June 8, 2011

RE: ODNR WEST BRANCH STATE PARK
PERMIT NO. 3PP00010
PORTAGE COUNTY
RAVENNA

Figure 1

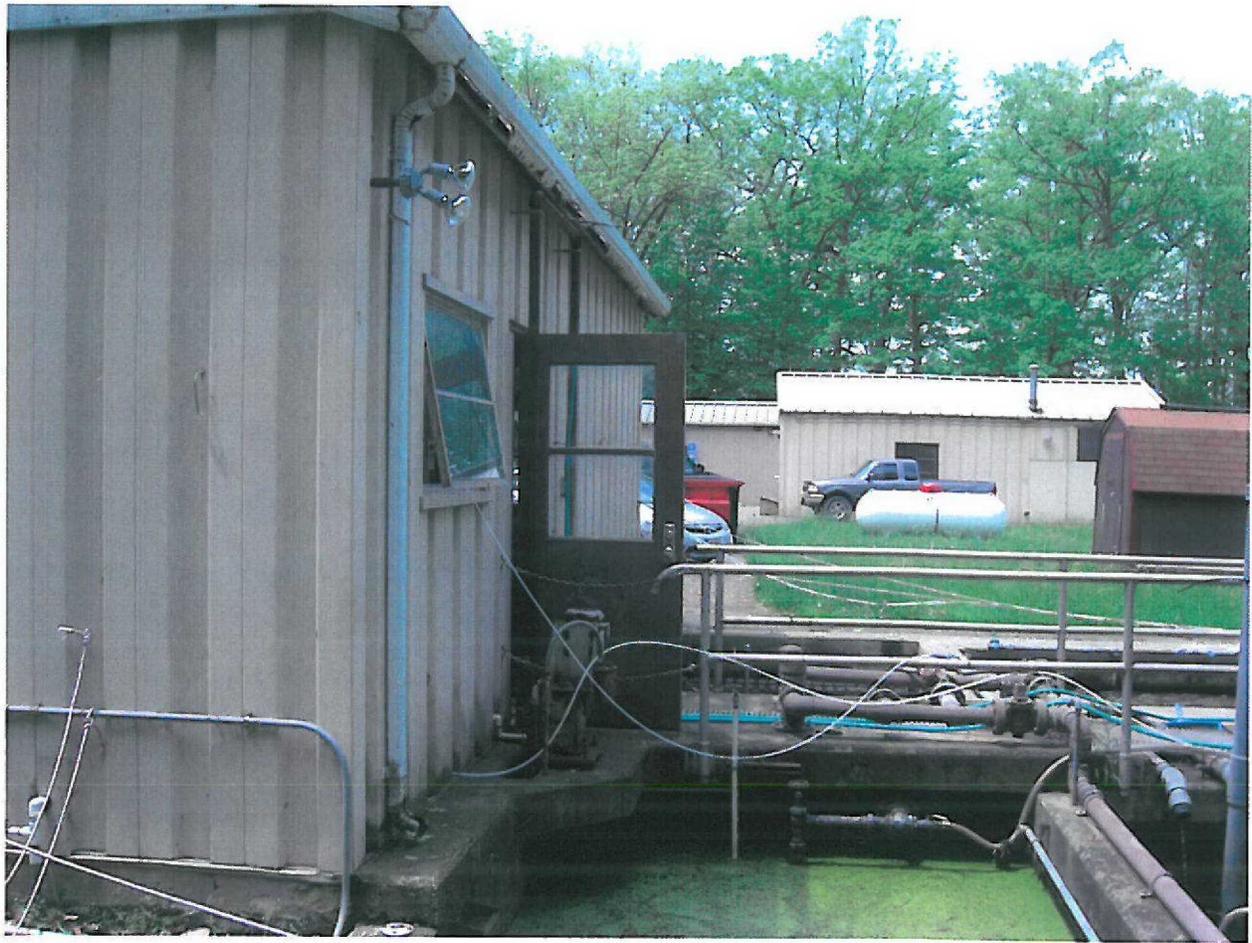
13. The storm water downspouts from the blower building drain directly into the clarifiers. Also the bottom of the gutters are severely deteriorated which also allows storm water to enter the clarifier. See Figure 1. This can cause hydraulic overload of the clarifier and result in a poor quality effluent. The gutters should be repaired immediately and be rerouted so that they do not discharge into the clarifiers
